Three Mile Island Nuclear Station Unit 1 (TMI-1)  
Operating License No. DPR-50  
Docket No. 50-289  
Error Analysis - Subcooling Margin Indication

GPUN RESPONSE TO NRC QUESTIONS ON TMI-1 SATURATION  
MARGIN MONITOR LOOP ERROR ANALYSIS

Figure 1

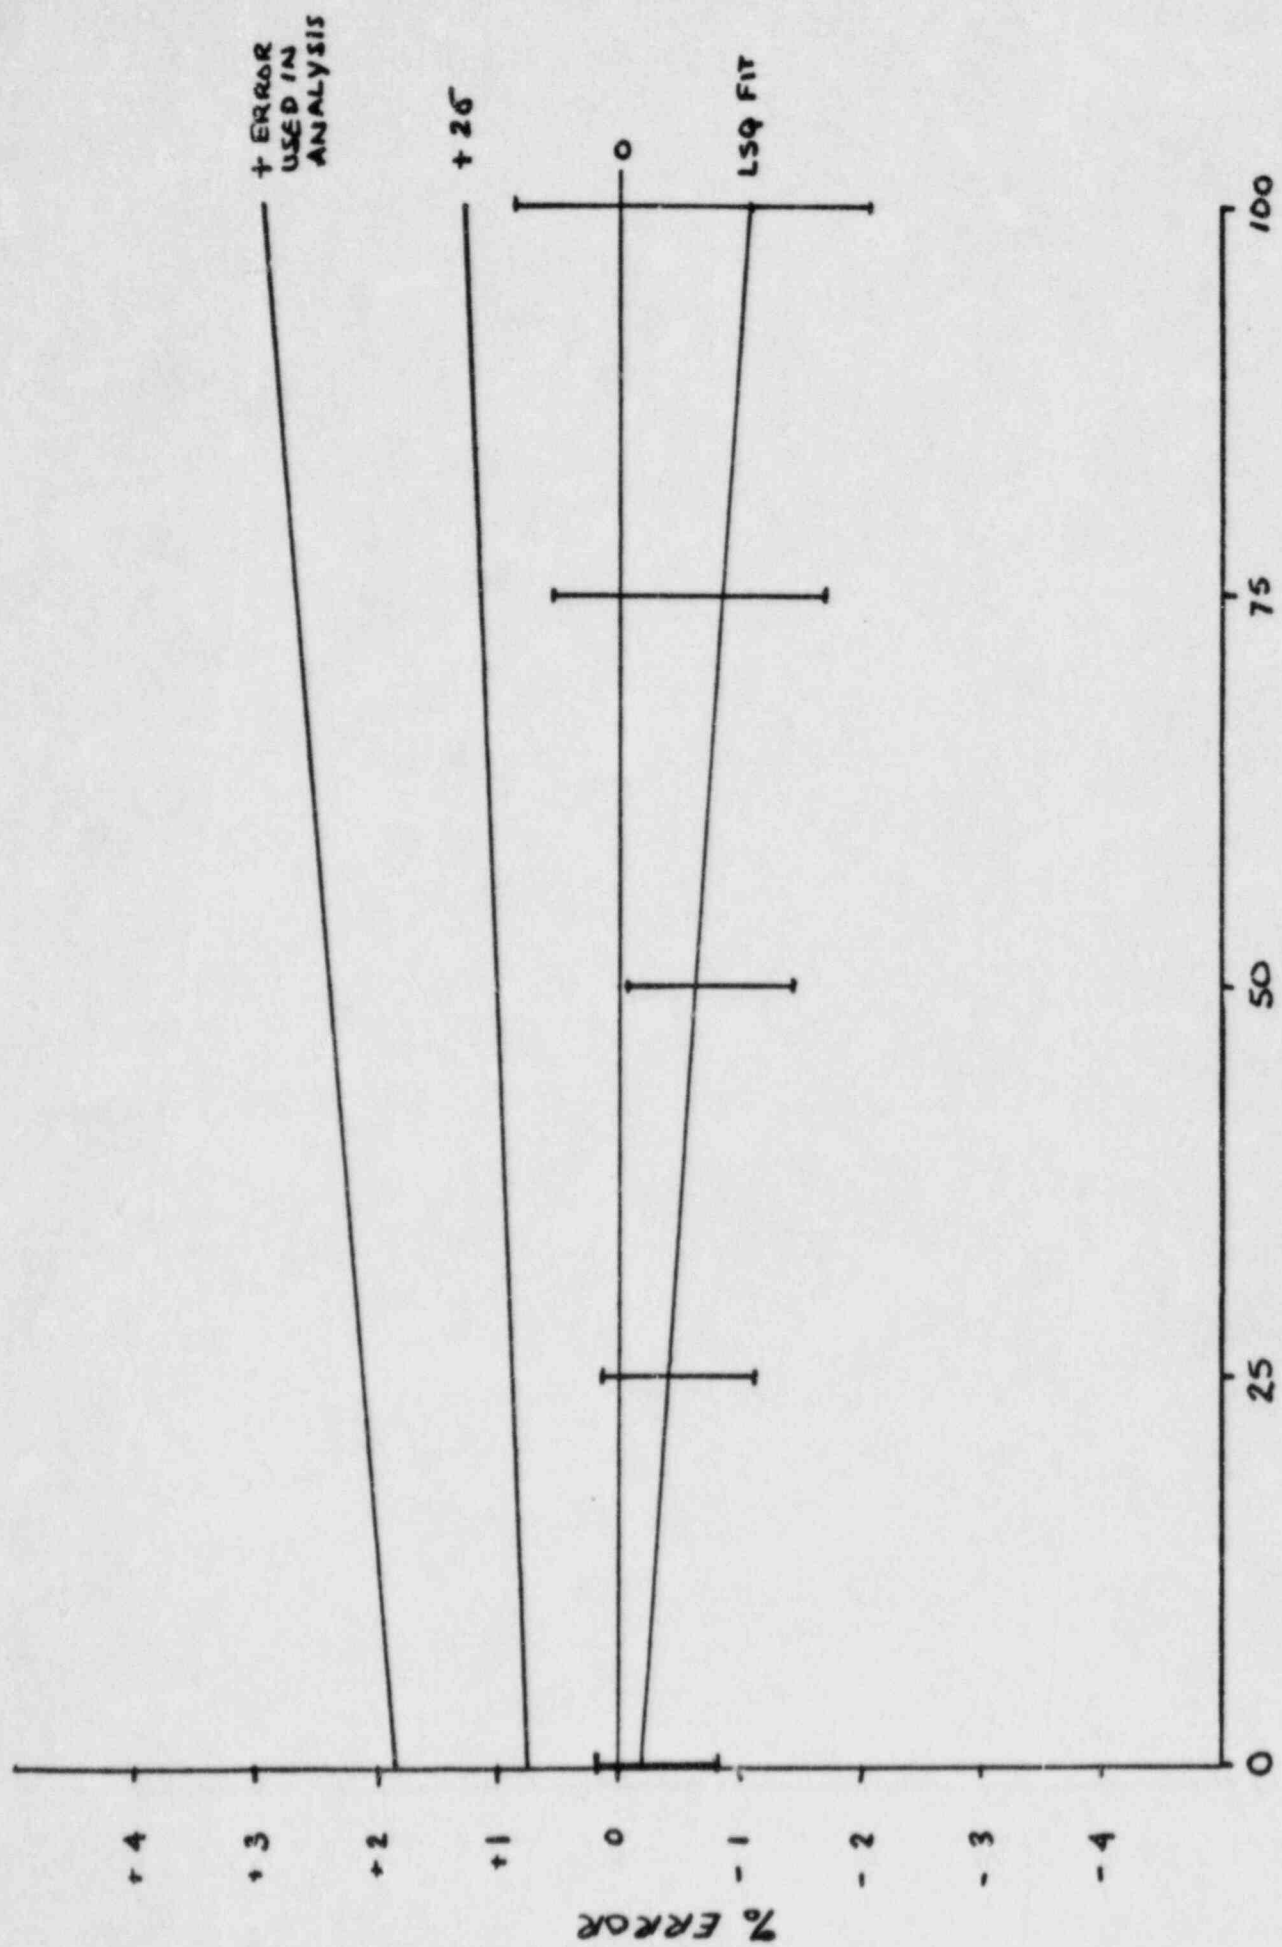
Sheet 2 of the loop error analysis discusses the error allowance for the steam line break and small break LOCA conditions. For the purpose of determining the error allowance, the manufacturer's test results for more severe accident conditions were divided by a factor of three. It is the staff's concern that this may be nonconservative. Manufacturer's tests are typically one time tests that yield a single curve or data point. In lieu of requiring that several tests be performed with a statistical evaluation of the results, the staff has accepted a single curve or data point provided there is conservatism in the temperature and radiation levels. Accordingly, we request that additional information be provided to support this method of estimating the environmental error allowance.

Based on LOCA/HELB tests, the manufacturer specified the  $3\sigma$  LOCA/HELB error as follows:

Subsequently, we evaluated the validity of the assumed SBLOCA equation by analyzing actual test data taken at 240°F and comparing it with the SBLOCA error equation.

The test data for the five transmitters has been plotted on Figure 1 (vertical lines at 0, 25, 50, 75 and 100 percent of span). The line of regression was then determined by the method of least squares.

The error of interest is the  $+2\sigma$ , since it would indicate a higher subcooling margin than the actual margin. The  $+2\sigma$  values have been plotted on Figure 1, demonstrating that the values used in the loop error analysis were indeed conservative.

Figure 2

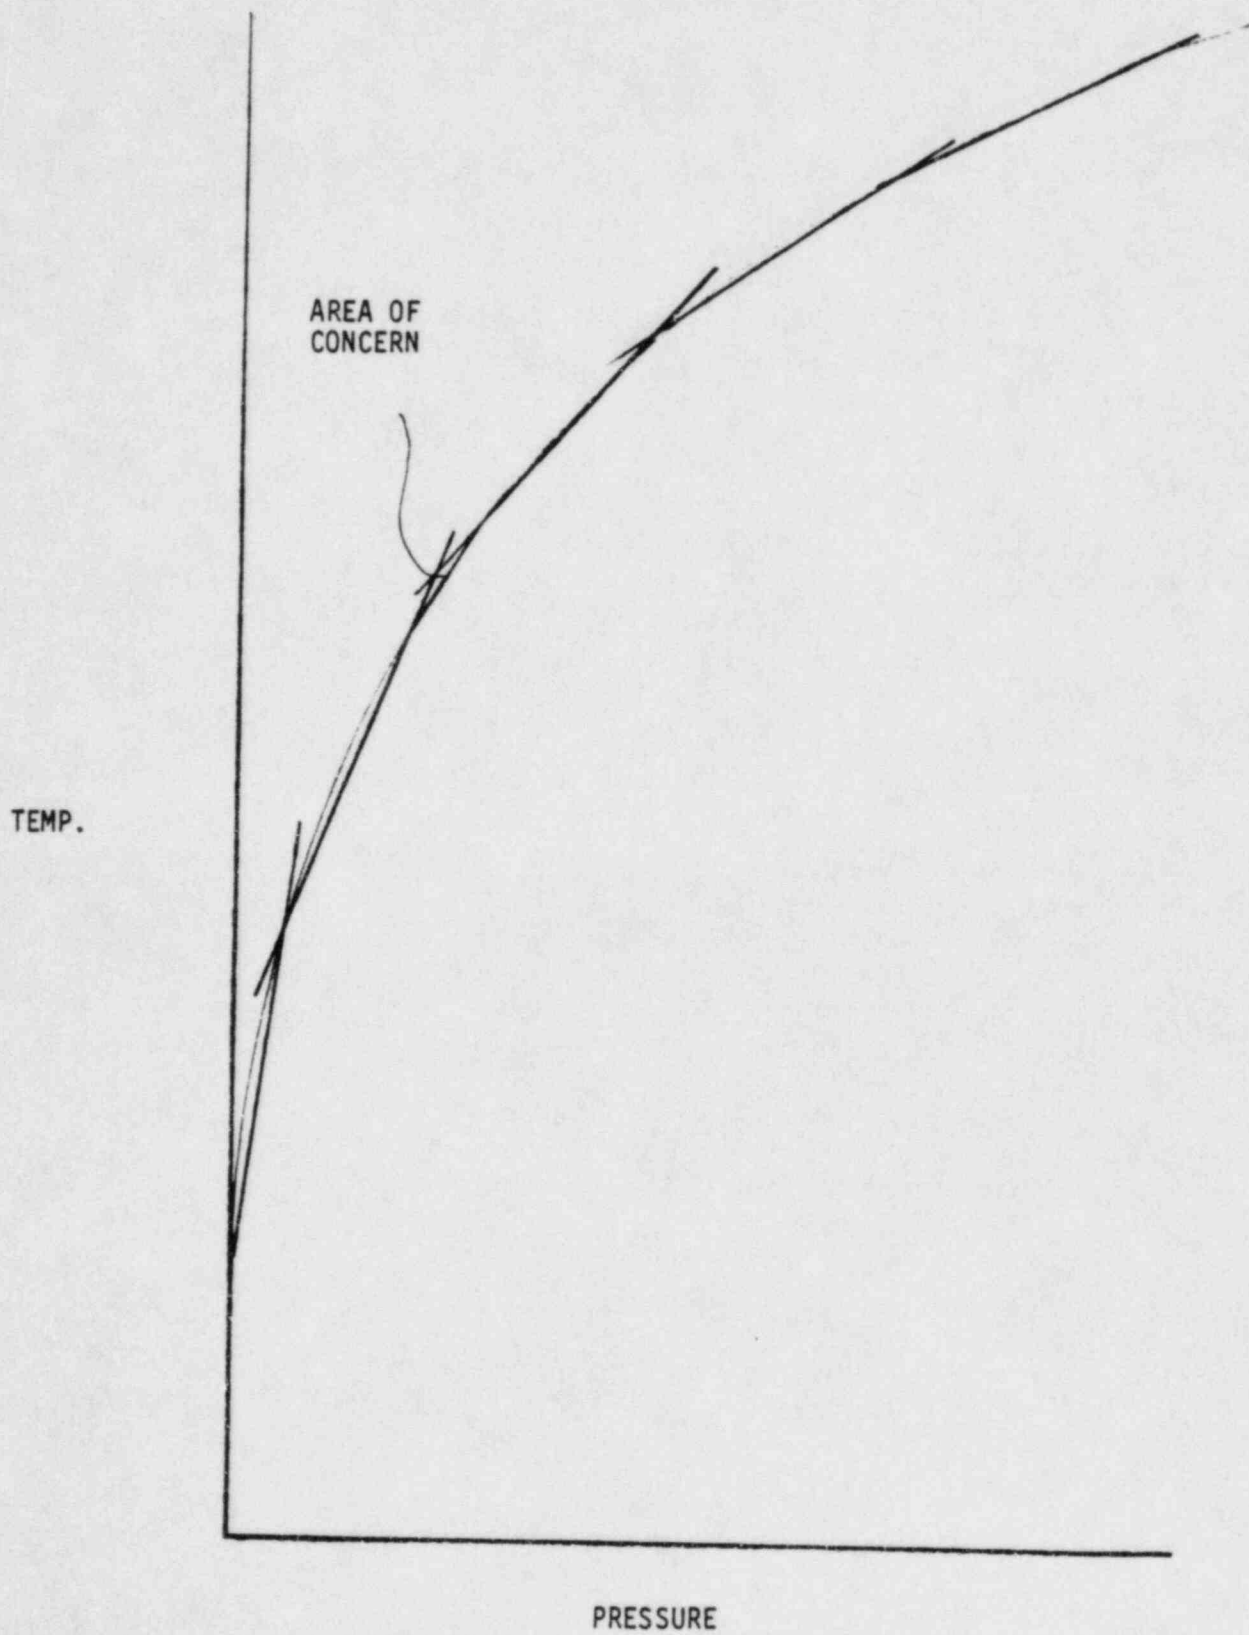
Table 3 on sheet 5 of the loop error analysis provides the total alarm loop uncertainty. The discussion preceeding Table 5 states that the total positive (nonconservative) error is the positive random error alone. We request that you provide the basis for neglecting the systematic error associated with the characterizer curve, and provide the equations for calculating the values shown on the Table.

1. Figure 2 shows a representative characterizer curve.

The actual characterizer is designed with eight linear segments. These eight linear segments which approximate the temperature-pressure saturation curve were plotted on the concave side of the curve, and provide a saturation temperature lower than actual (conservative). As calculated, the line segments intersect adjacent line segments at or slightly above the curve. However, according to the manufacturer (Foxboro product specification TI 2AP-140) "the transition from segment to segment is a smooth curve which follows the characteristics of a diode junction."

The positive values shown on sheet 26 of the calculation were calculated to determine their magnitude if smoothing did not occur, and do not represent the actual output of the characterizer.

Positive values of systematic characterizer curve errors were not included in the calculation because:

- a) They occur at only seven very narrow regions of pressure.
- b) Their calculated positive values before smoothing are all less than 1°F, and this value is smoothed in the negative direction.

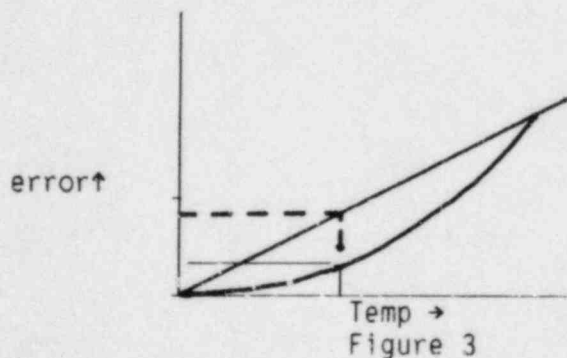
Notes 1 and 2 on Sheet 6 of the loop error analysis provide qualitative basis for the use of statistically less conservative error allowances for temperature effects and power supply effects. We request that you provide test results or analyses to confirm the linear relationship between error and power supply/temperature variation.

1. With regard to Note 1 on Sheet 6, the qualitative basis for derating the temperature effect error is that the equipment (Foxboro 200 modules) are located in the Control Building, which has redundant safety grade HVAC systems. A controlled environment of  $\pm 5^\circ\text{F}$  will always be available.

Foxboro published error data is based on a  $50^\circ\text{F}$  heat rise of the modules. During the testing, temperature was changed in large increments ( $23^\circ\text{C}$ , then smaller increments until limit was reached), and an error limit (less than  $\pm .5\%$ ) was established that enveloped the worst case test data. The test data indicates that temperature effect error increases as temperature deviates further from the reference temperature of calibration to some function with a power greater than one. Thus a linear interpolation is conservative. (See Figure 3, below)

Figure 4

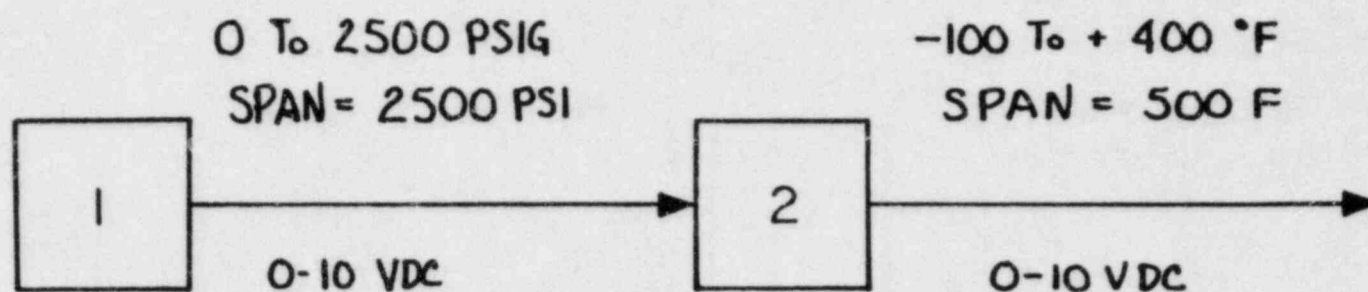
Sheet 10 of the loop error analysis states that the error for modules 9 and 10 must be multiplied by the slope of the saturation temperature/pressure curve ( $dT/dp$ ). Over the pressure range of interest, the multiplication factor is less than one, reducing the error associated with modules 9 and 10 by a factor of 14 at the upper range. As discussed in Enclosure 1 to the letter dated August 31, 1984, from H. D. Hukill (GPU) to J. F. Stolz (NRC), this multiplication factor is necessary to correct for the amplifier gain in the function generator. From a review of the information provided, it is not clear why the uncorrected value for modules 9 and 10 are nonconservative and how you determined that  $dT/dp$  was the appropriate correction factor. Accordingly, we request that you provide additional information to support the use of the  $dT/dp$  correction factor in computing error.

The problem at hand is to express an individual component error, given as a percent of a 2500 psi span, as a percent of a 500°F span (the final elements of the loop), in order that it may be added as part of the overall loop error.

As shown in Figure 4, the following steps are followed:

1. Convert the individual component error value (a percent of the 2500 psi span) to an absolute value in terms of psi, by multiplying by (2500 psi/100% span 1).
2. Convert the error (psi) to an error (°F) by multiplying by  $dT/dp$  (°F/psi).
3. Convert the error value in °F to a percent of span for the final components by dividing by (the span in °F/100 % span 2), or (500°F/100% span 2).

The omission of  $dT/dp$  was equivalent to the assumption of  $dT/dp = 1$ . As discussed in Enclosure 1 to the August 31, 1984 letter and as shown on page 11 of the loop error analysis, the use of  $dT/dp = 1$  resulted in calculated error values which were nonconservative by a factor of 1.264 in the 0-100 psig range, and overly conservative in the ranges above 100 psig.
